RFB NO. 311010- ADDENDUM NO. 1

STAIRWELL DOORS HARDWARE UPGRADE

CITY-COUNTY BUILDING

AD1.A2.2

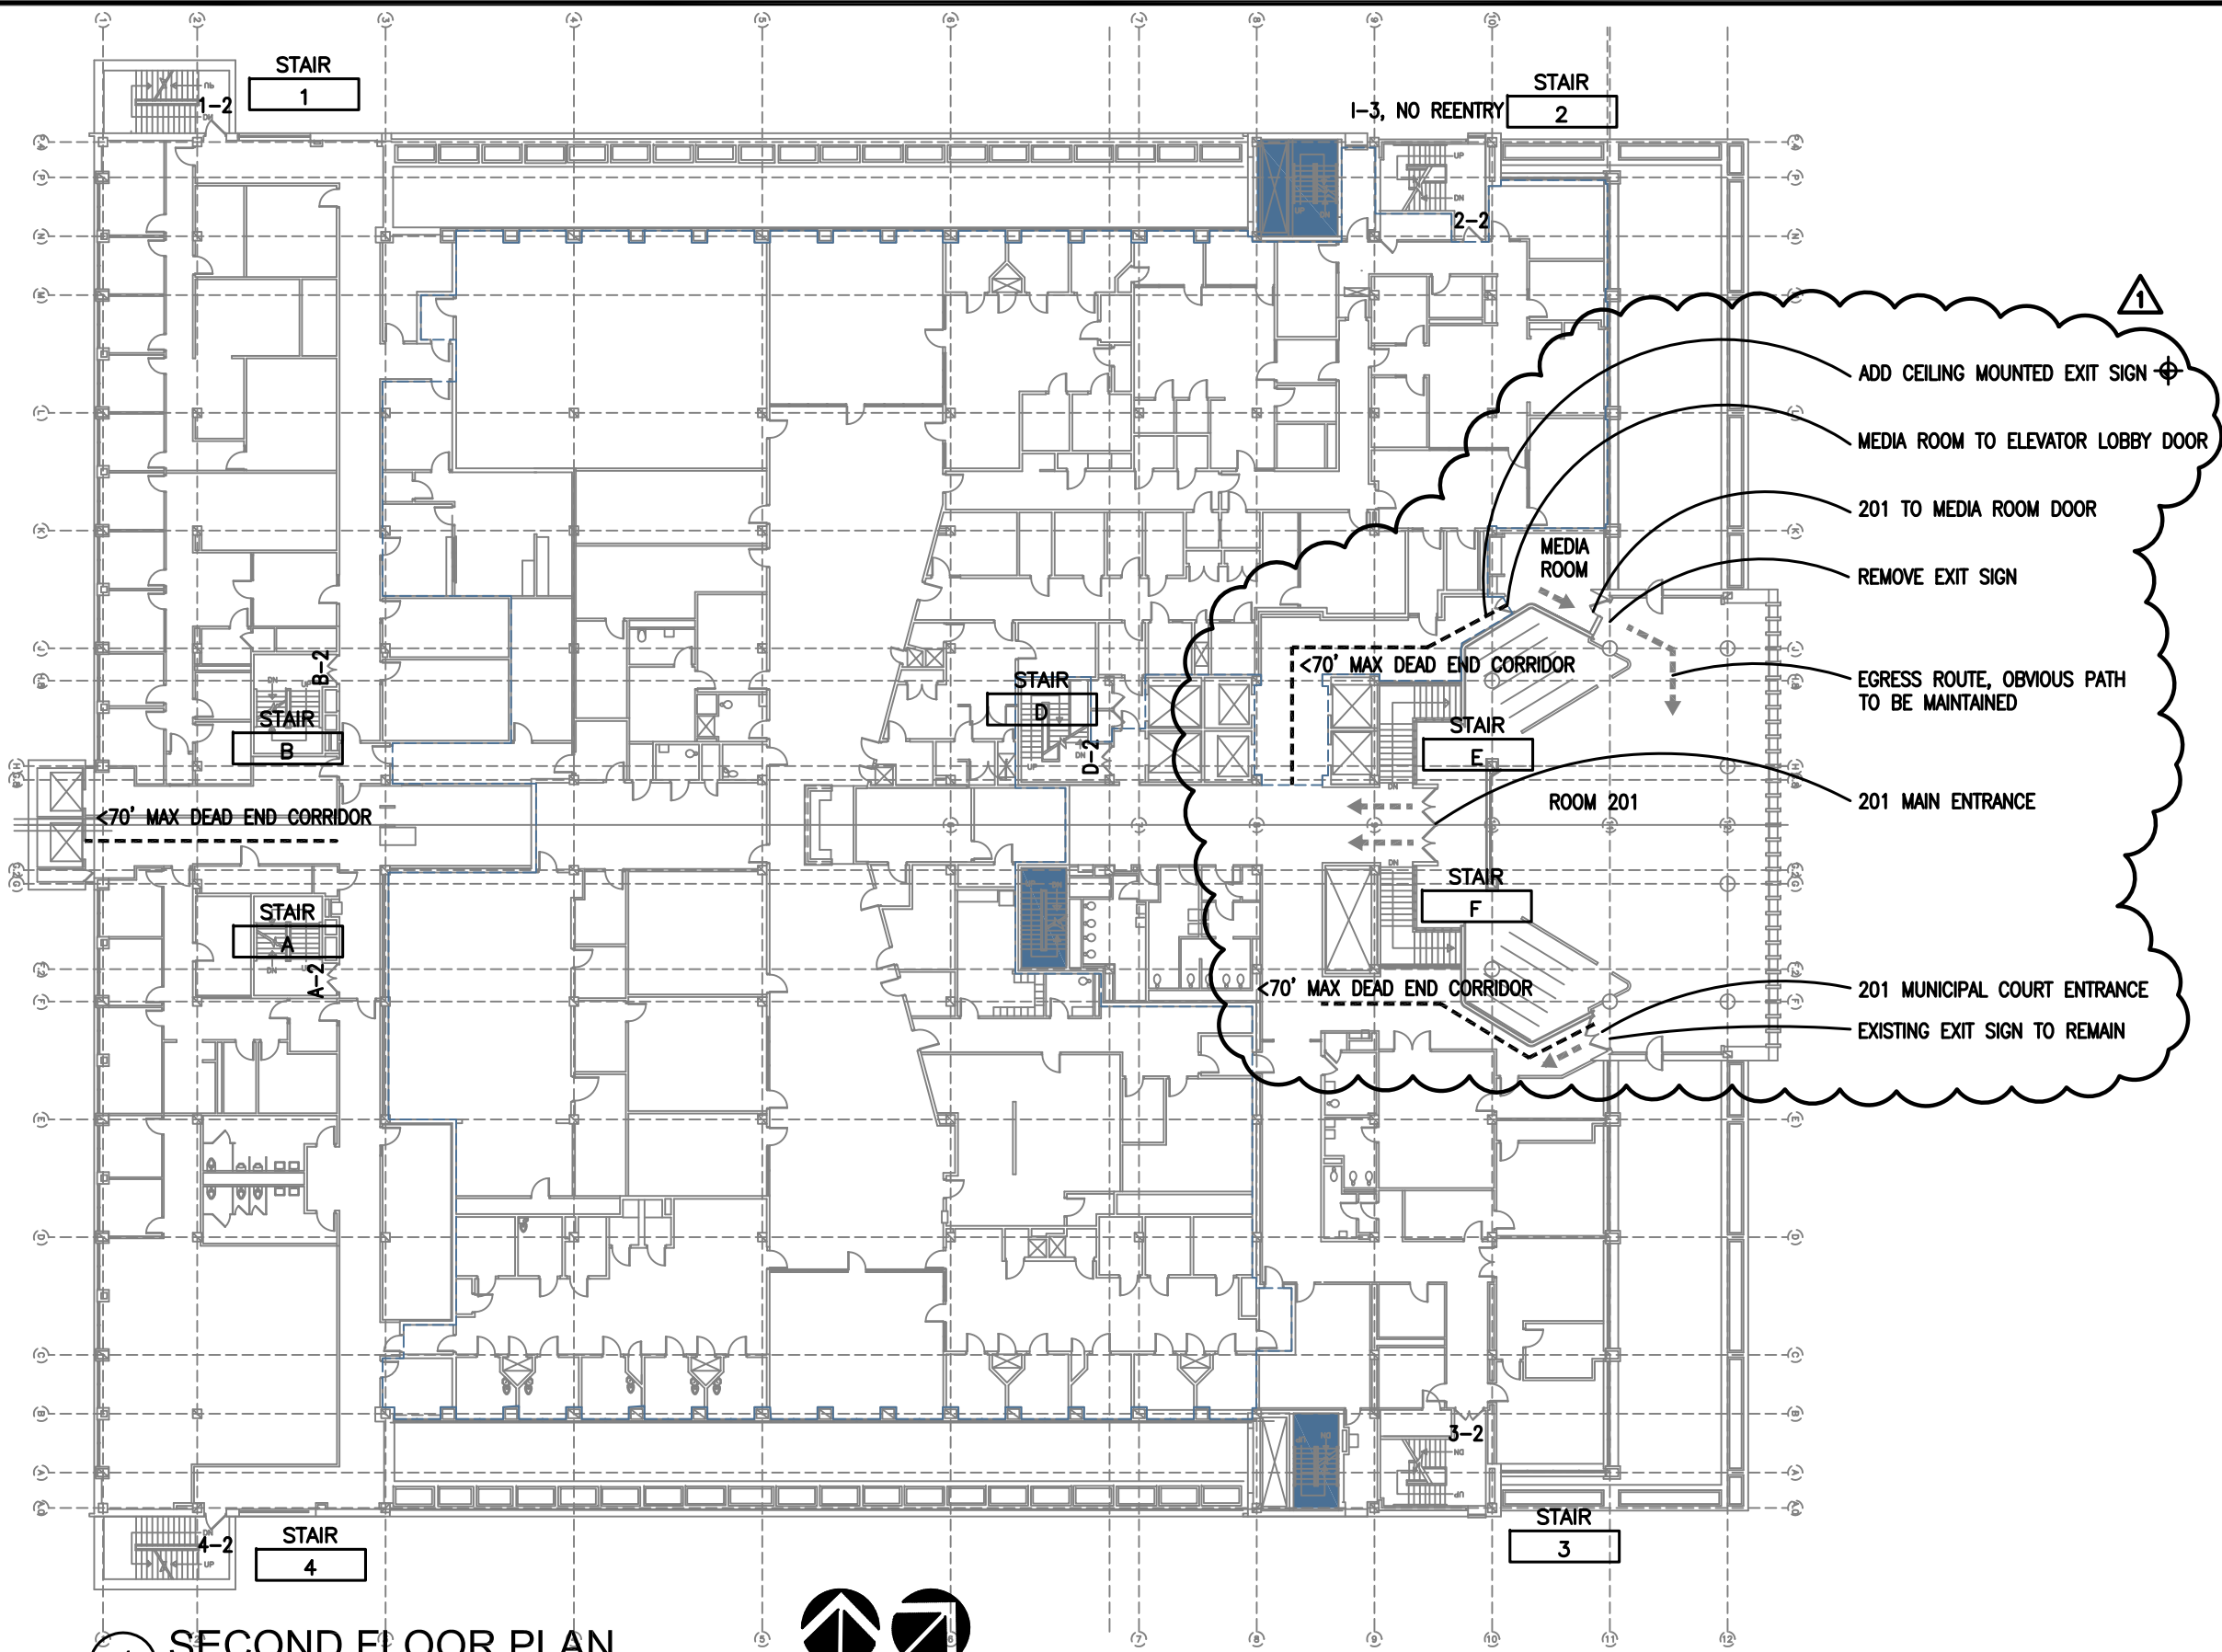
1. Add exit light

- a. Confirm to UL 924, sign color to conform to local code, self-powered, battery type. Refer to attached AD1.A2.2 for location.

2. Remove exit light in Room 201.

- a. Refer to attached AD1.A2.2 for location.

3. 201 Main Entrance (2 Pairs)

- a. Remove existing lockset from both pairs.
- b. At both pairs, add new Adams Rite 4910 dead latch with 4590 exit paddle on the push side, and a Best Mortise Cylinder, keyed to building's key system, on the pull side.
- c. Refer to attached AD1.A2.2 for door location.

4. 201 to Media Room Door

- a. Remove Existing Lockset.
- b. Add new 93K-N-16D-626 From Best Access Systems.
- c. Refer to attached AD1.A2.2 for door location.

5. Media Room to Elevator Lobby Door

- a. Remove Existing Lockset.
- b. Add new 93K-N-16D-626 From Best Access Systems.
- c. Add the following components from Securitron
 - i. M32 x ZA-32 Magentic lock and Z-Bracket

- ii. SB-MXD – Door Movemnet Sex Bolt Kit
 - iii. BA-XDT – Exit Delay Timer
 - iv. XMS – Exit Motion Sensor
 - v. MK Key Switch with Best Mortise Cylinder, keyed to building’s key system.

- vi. BPS – Power Supply
- d. Opening to function as follows:
 - i. Door normally closed and locked. Upon approach from push side, motion sensor will shunt delayed egress system and allow immediate egress from Media Room. From pull side, using card reader (by Owner) will shunt delayed-egress system and allow entry from Elevator Lobby to Media Room. Pulling on door for greater than 1 second, without using card reader, will sound local alarm. After 15 seconds, magnetic lock will release and allow door to be opened.

- e. Provide signage on door: “Emergency Exit, alarm will sound, turn lever for 15 seconds and pull”. Confirm text with Architect to meet Fire Department requirements.

- f. Refer to attached AD1.A2.2 for door location.

6. 201 Municipal Court Entrance (Pair of Doors)

- a. Remove existing deadbolt from active leaf.
- b. Modify door to receive new hardware.
- c. Provide new Adams Rite 4920AN dead latch with 4590 exit paddle on the push side, and a Best Mortise Cylinder, keyed to building’s key system, on the pull side.
- d. Refer to attached AD1.A2.2 for door location.
